REMARKS

B. Drawings

During the course of Applicant's review of the specification and drawings in preparation for responding to the Official Action, Applicant discovered the informalities identified below in the drawings. Accordingly, applicant requests permission to amend the drawings in the following manners:

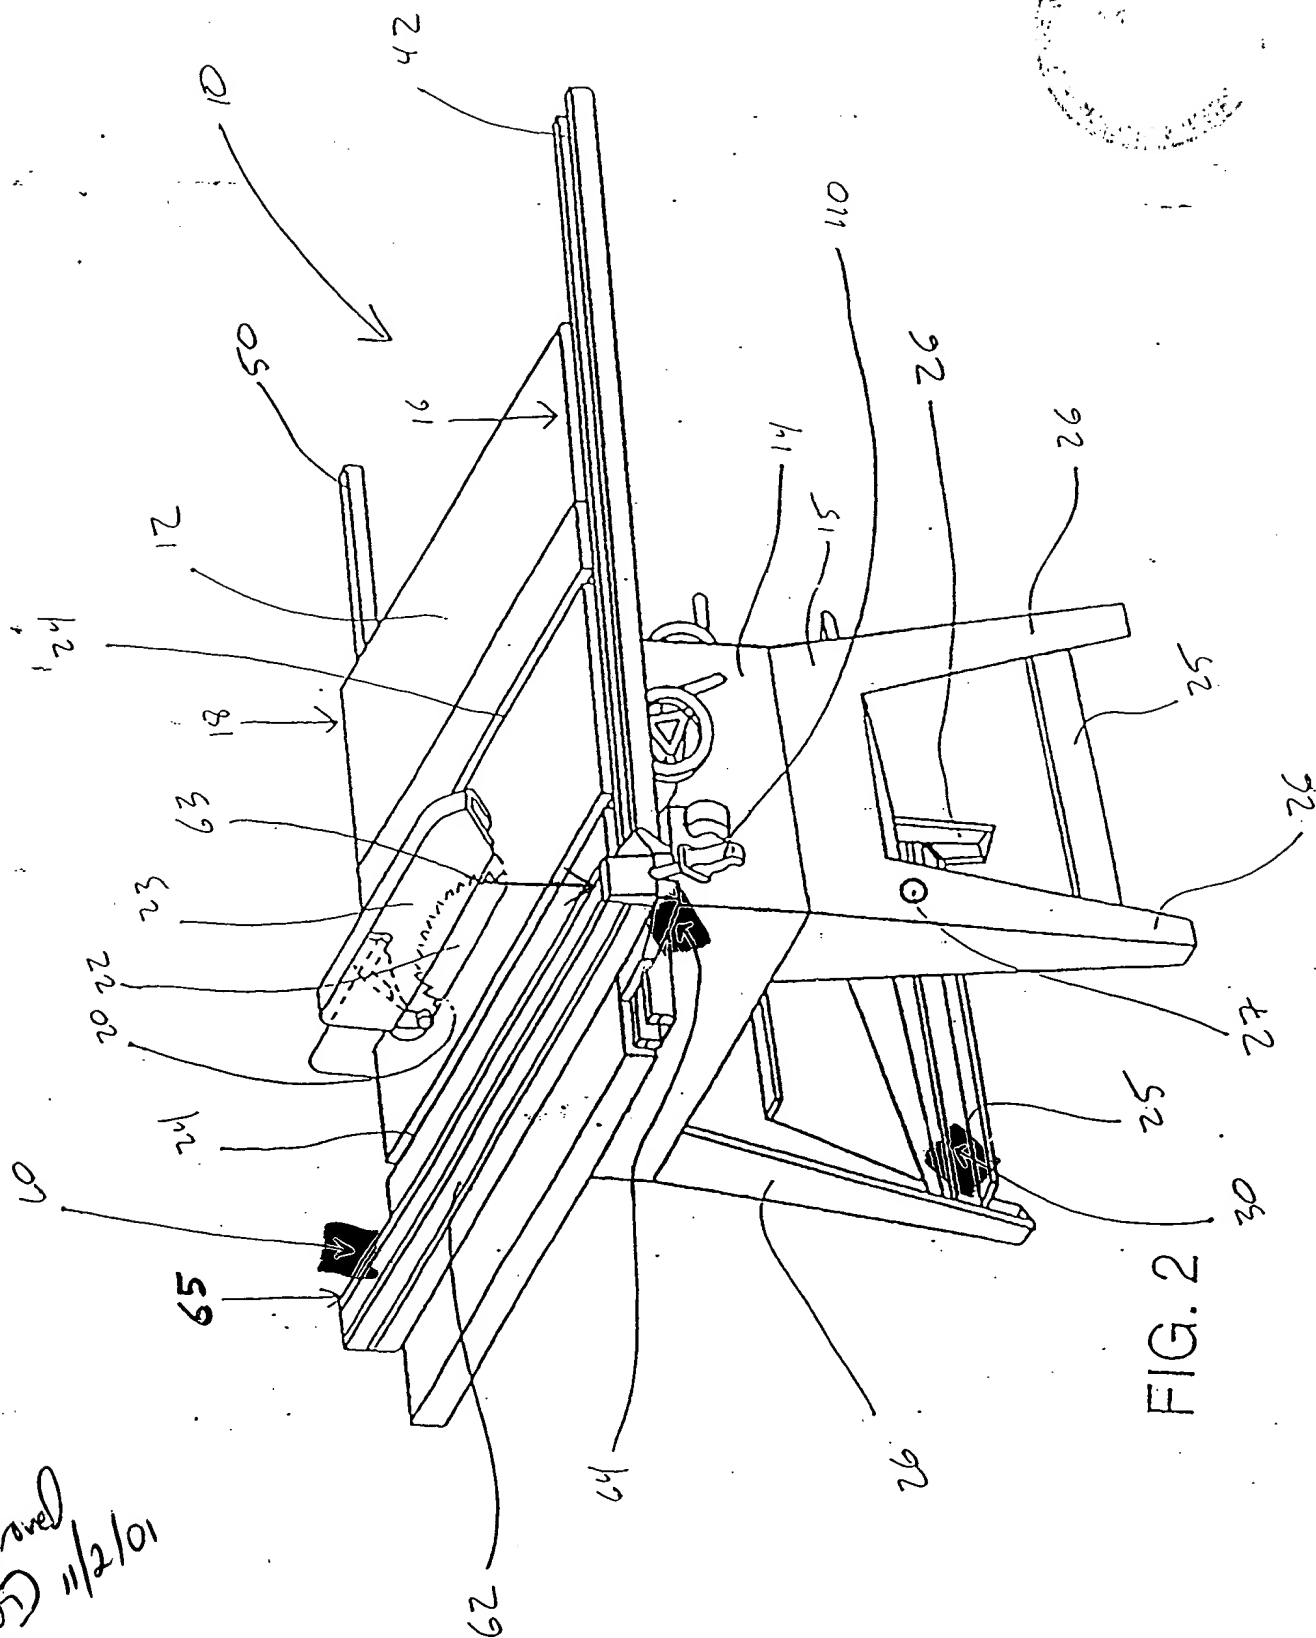
- Figure 2: Reference number "64" lead line amended to terminate with an arrow.
- Reference number "60" lead line amended to terminate with an arrow.
- Reference number "30" lead line amended to terminate with an arrow and redirected to point to proper element.

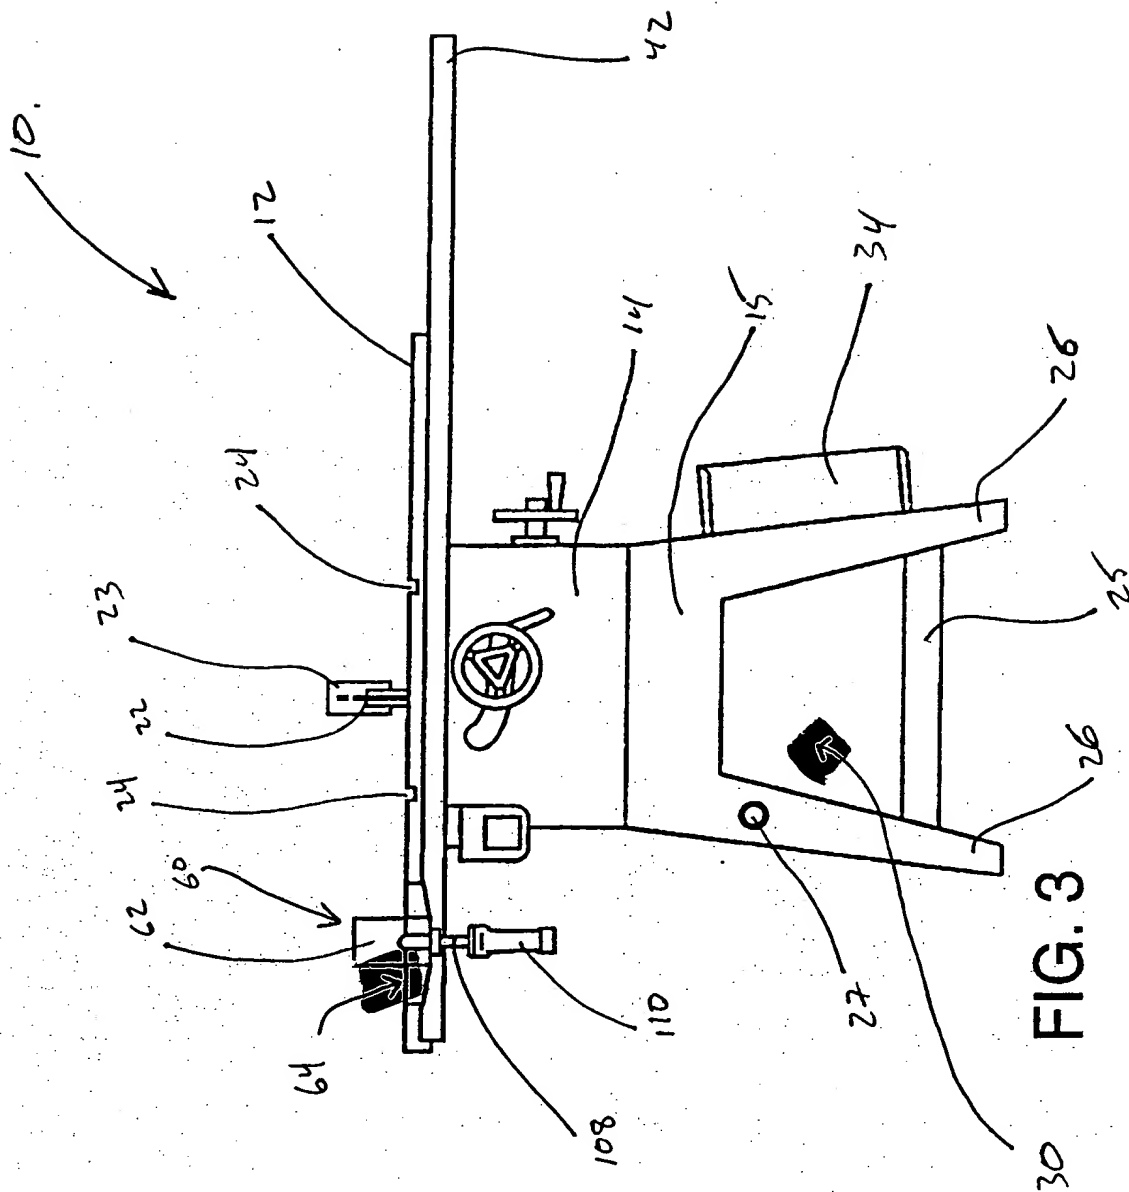
- Figure 3: Reference number "64" lead line amended to terminate with an arrow.
Reference number "30" lead line amended to terminate with an arrow.
- Figure 4: Reference number "98" lead line amended to terminate with an arrow.
Reference number "30" lead line amended to terminate with an arrow.

FIG. 5

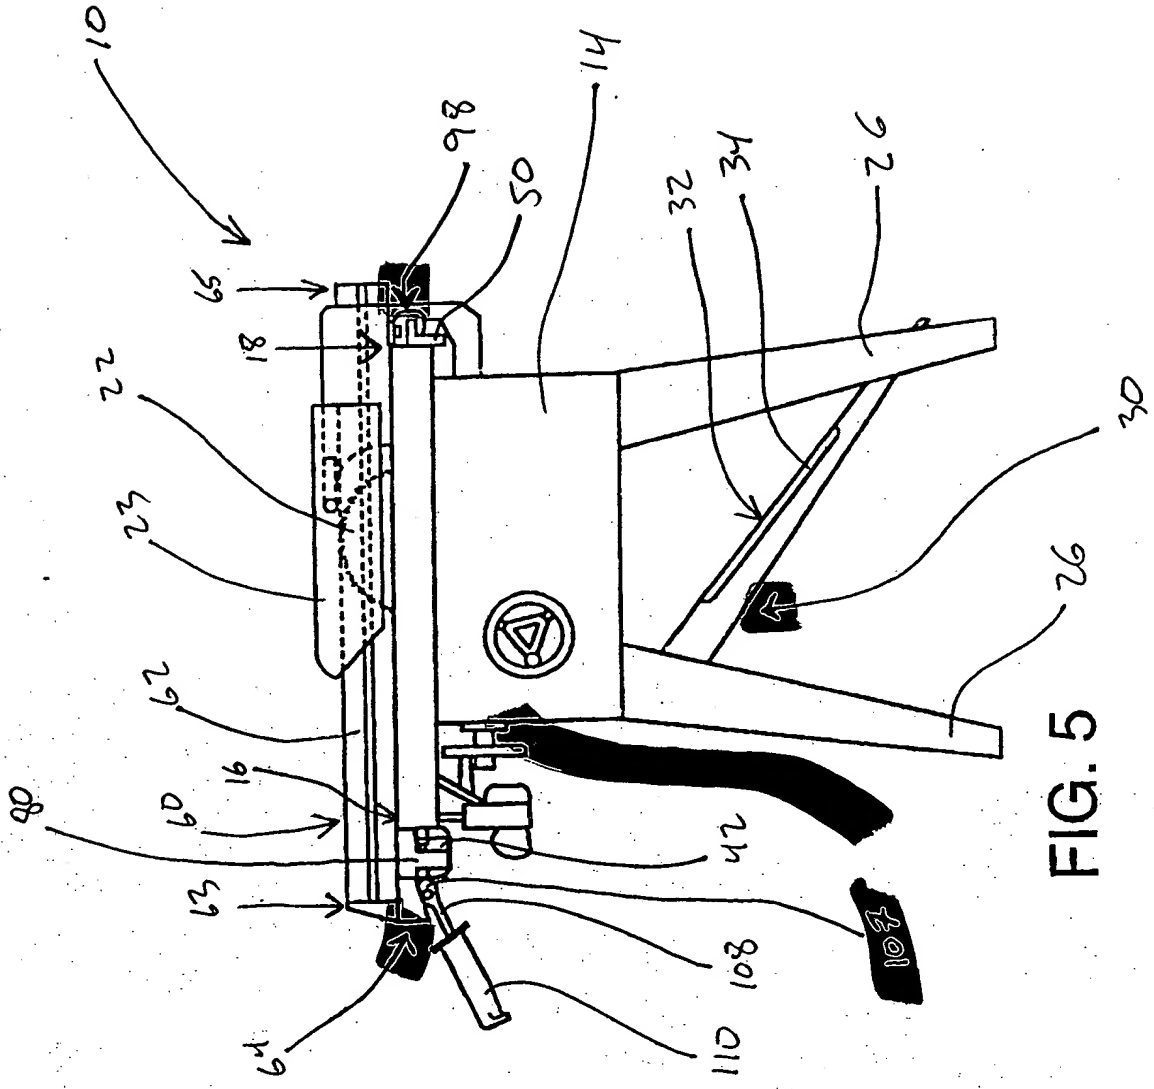
- Figure 5: Reference number "98" lead line amended to terminate with an arrow.
Reference number "30" lead line amended to terminate with an arrow.
Reference number "12" and reference number "12" lead line deleted.
Reference number "105" replaced with reference number "107" to properly show the element.
Reference number "64" lead line amended to terminate with an arrow.

FIG. 6

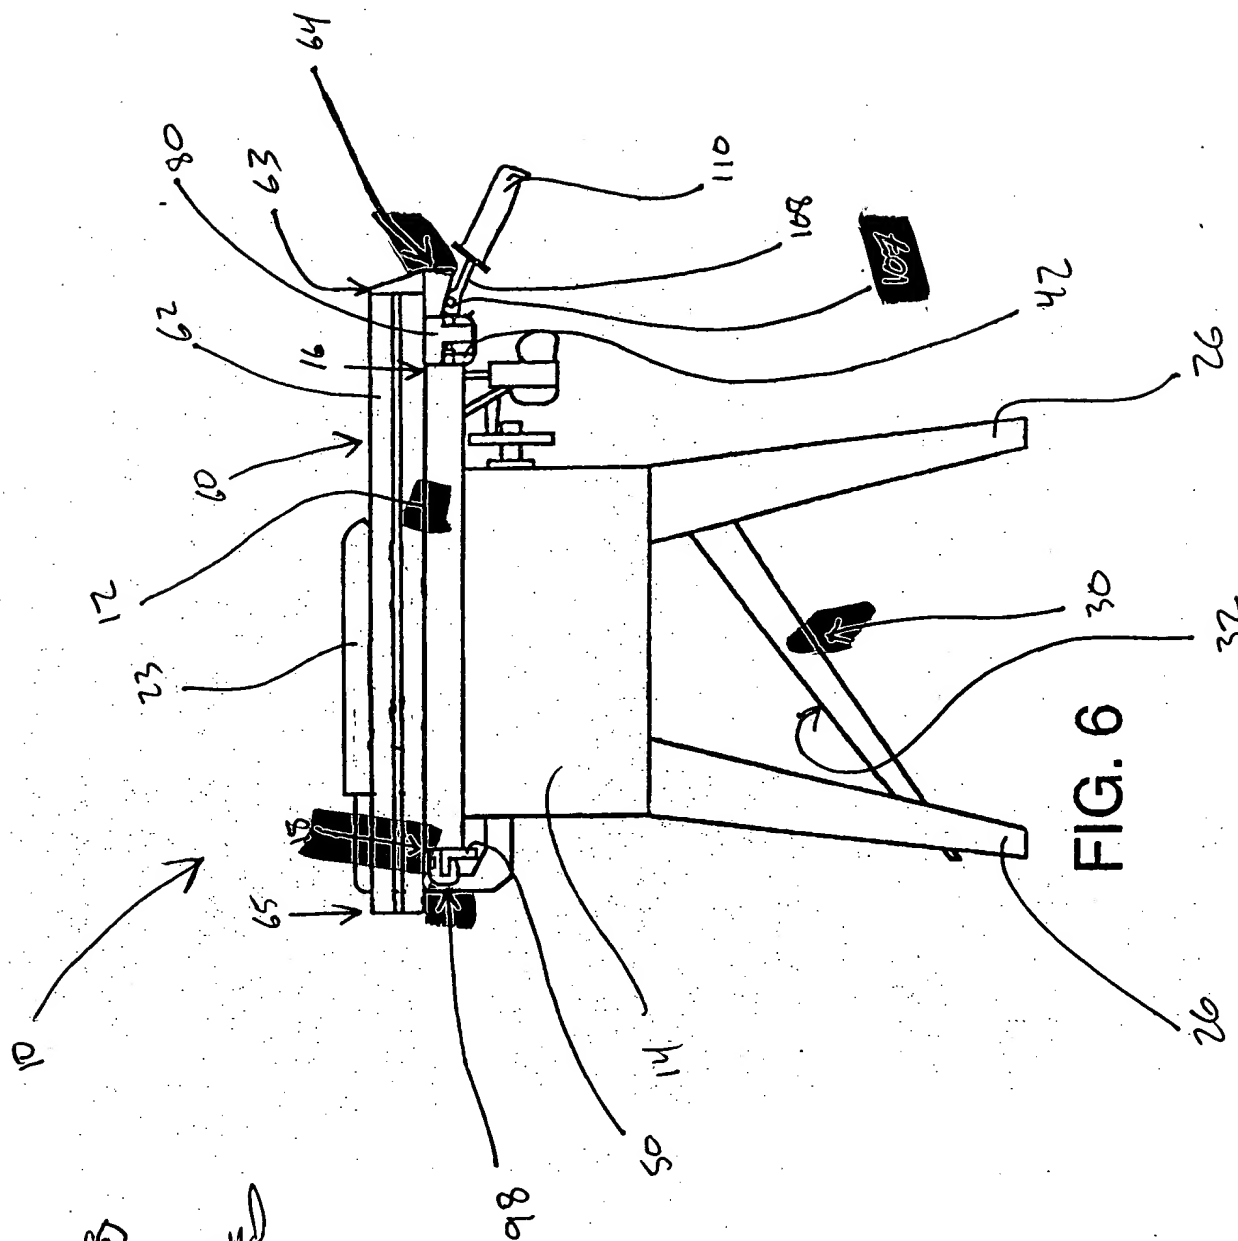
- Figure 6: Reference number "98" lead line amended to terminate with an arrow.
Reference number "18" lead line redirected to point to proper element surface.
Reference number "12" lead line redirected to point to proper element surface.
Reference number "64" lead line amended to terminate with an arrow.
Reference number "105" replaced with reference number "107" to properly show the element.
Reference number "30" lead line amended to terminate with an arrow.

FIG. 13

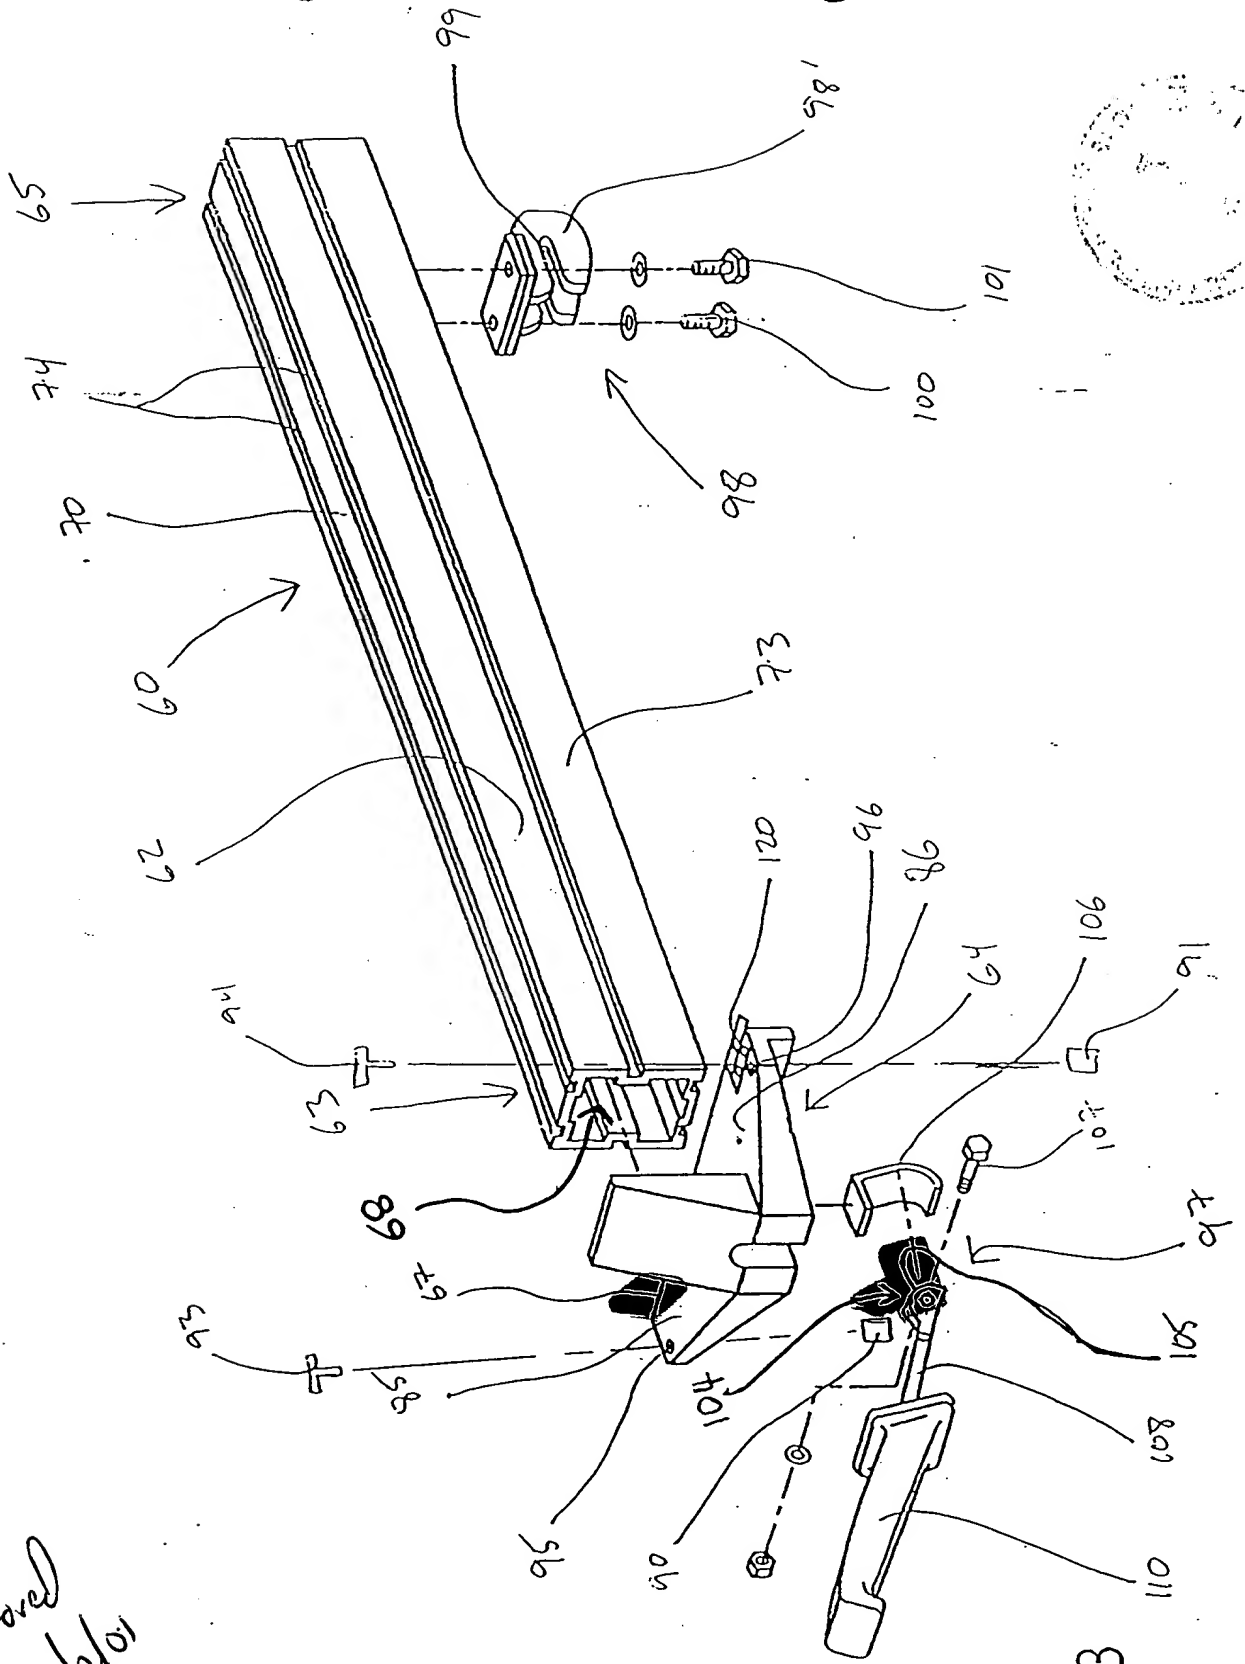
- Figure 13: Reference number "67" lead line amended to terminate without an arrow and redirected to point to proper element surface.
Reference number "104" lead line amended to terminate with an arrow.
Reference number "105" lead line amended to terminate without and arrow.

FIG. 14

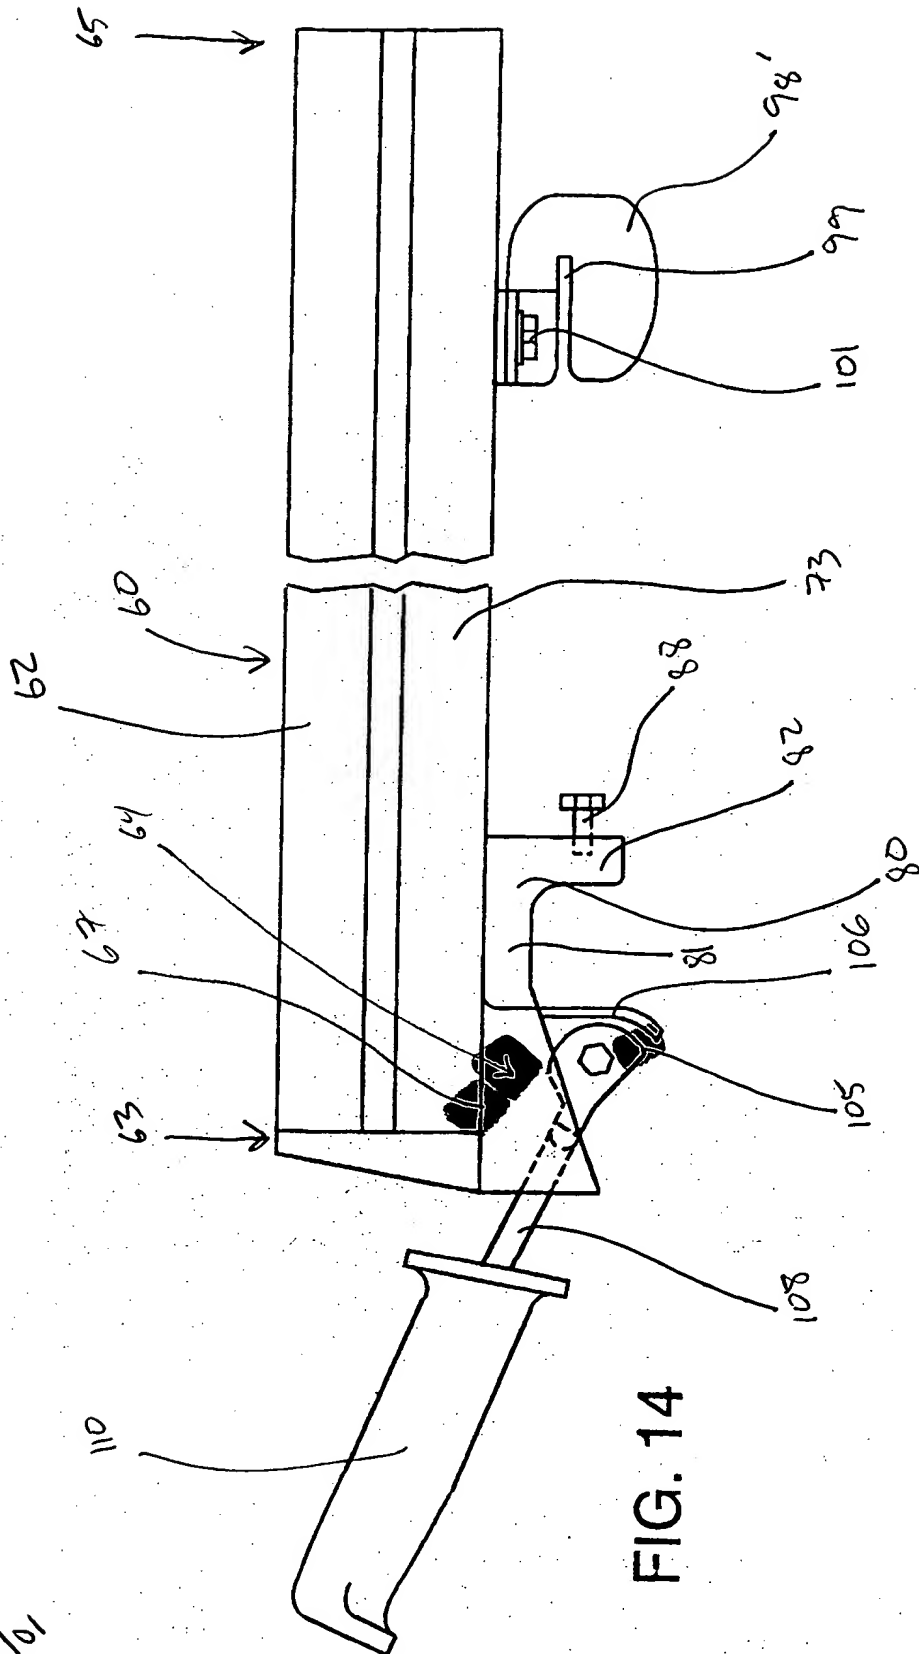
- Figure 14: Reference number "67" lead line amended to terminate without an arrow.
Reference number "64" lead line amended to terminate with an arrow.
Reference number "105" lead line redirected to point to the proper element surface.
